# Response to Technical Review Comments

## Clear River Energy Center and Burrillville Interconnection Project

Application No. 17-0079

**Re: Clear River Energy Center, LLC  
Burrillville RI  
Application No. 17-0079**

SHEET  
01C601  
9 OF 18

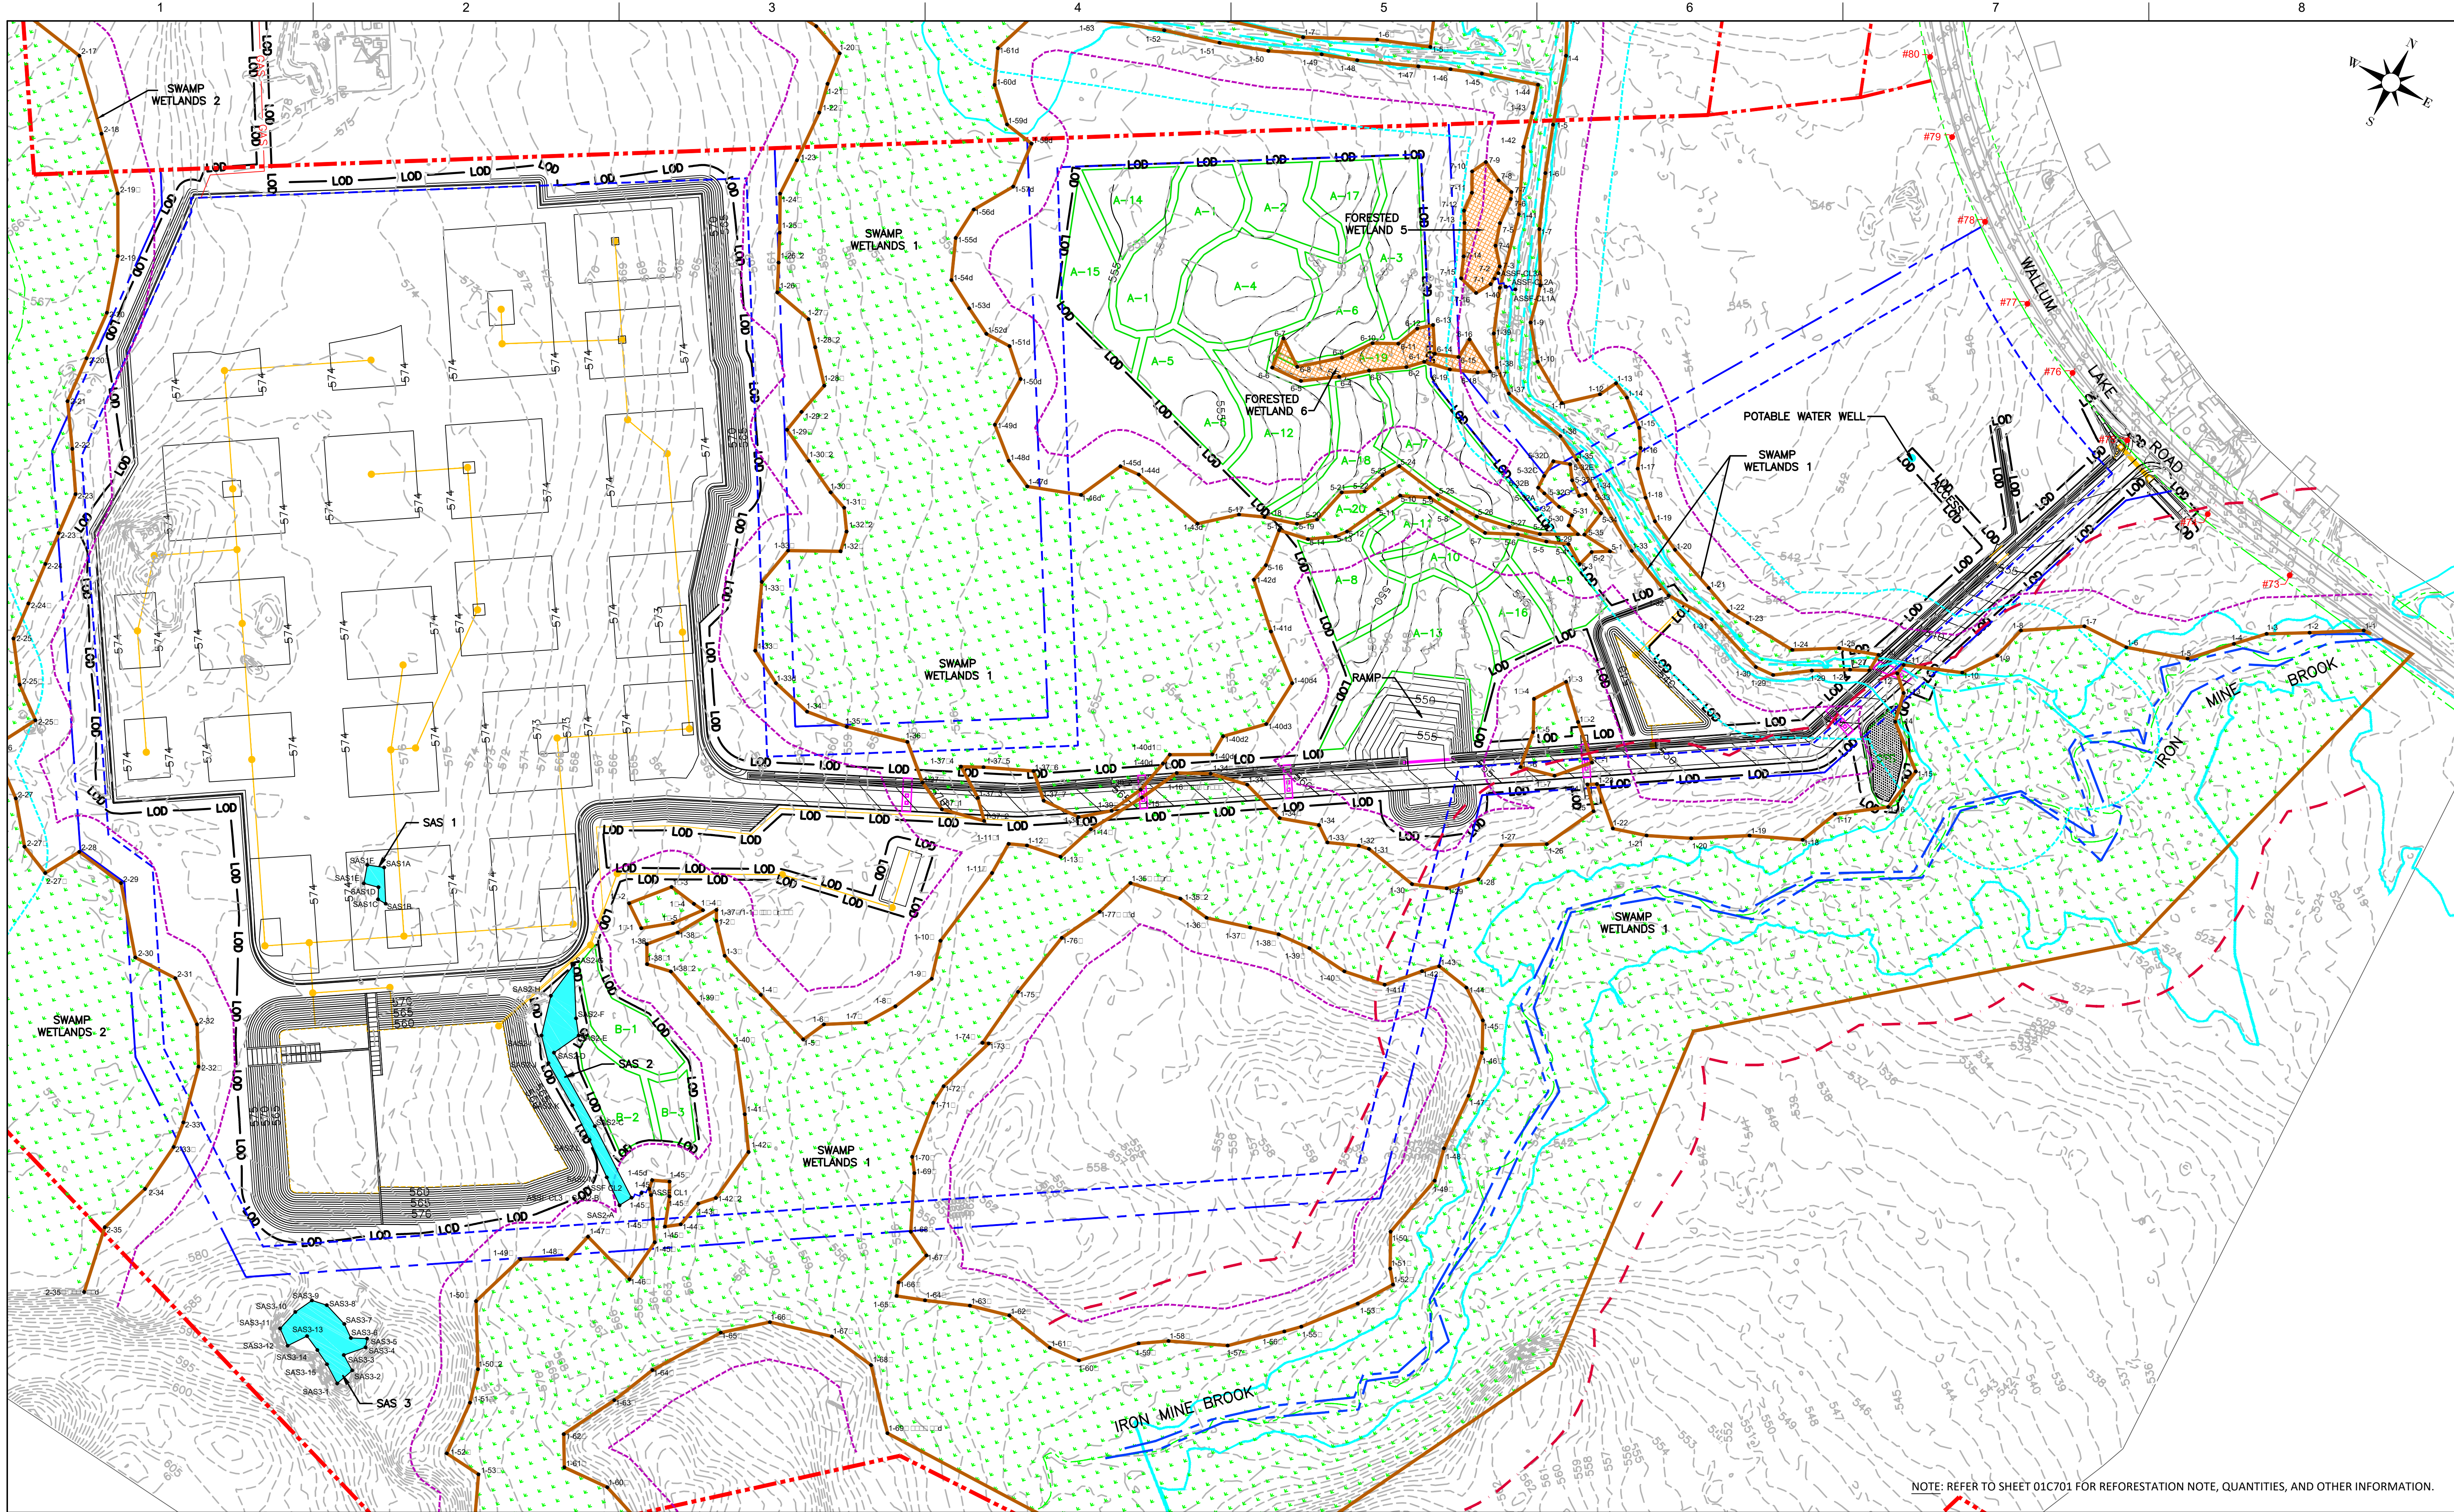
**Response:** The Roadway Plan and Profile sheets (Sheets 8 and 9 of 18) as well as the Utility sheet (Sheet 5 of 18) now show the proposed water and electric lines. Note that the electric line is labeled Under Ground Electric (UGE) and the Water Line as "W". The distribution of these utilities within the footprint of the plant will be designed by the EPC contractor at a later date, along with the rest of the underground utilities.

SHEET 01C701  
11 OF 18

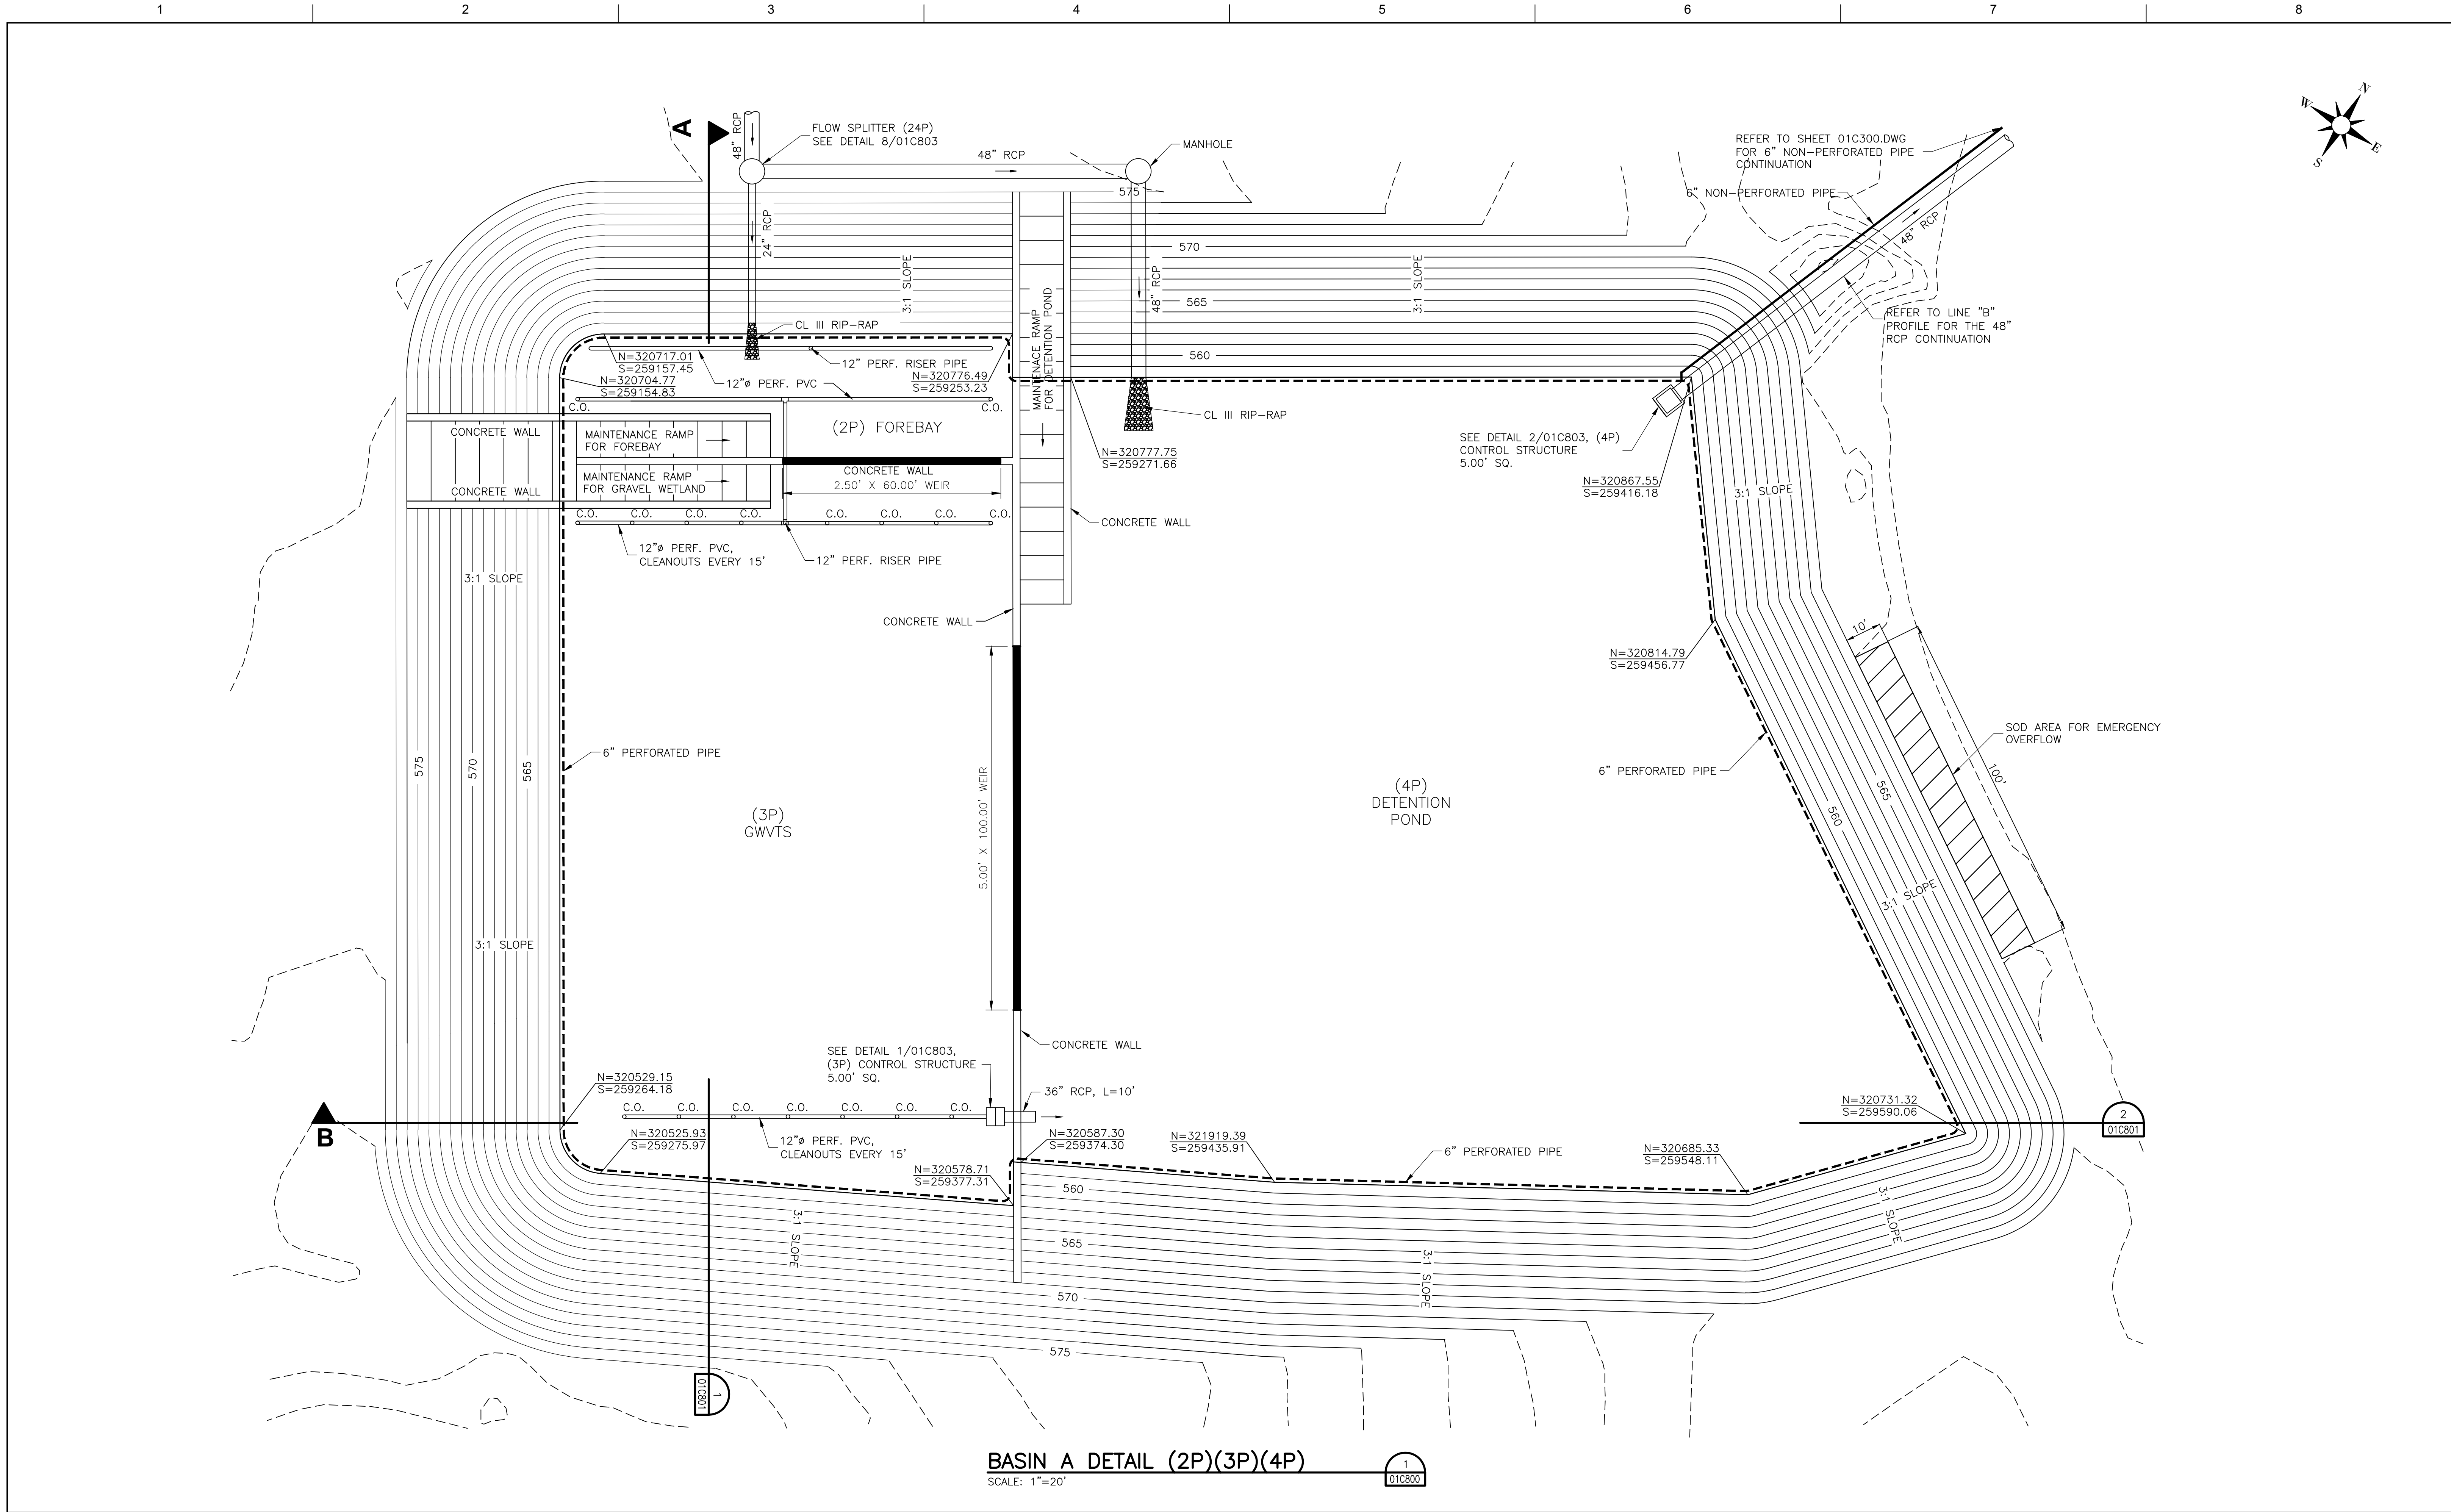
**Response:** The reforestation information has been darkened on the drawing (see Sheet 10 of 18) and the Plant Quantities and Planting notes have been moved to Reforestation Notes and Planting Schedule (Sheet 11 of 18) to provide clarity (see Exhibit 1 Volume I).
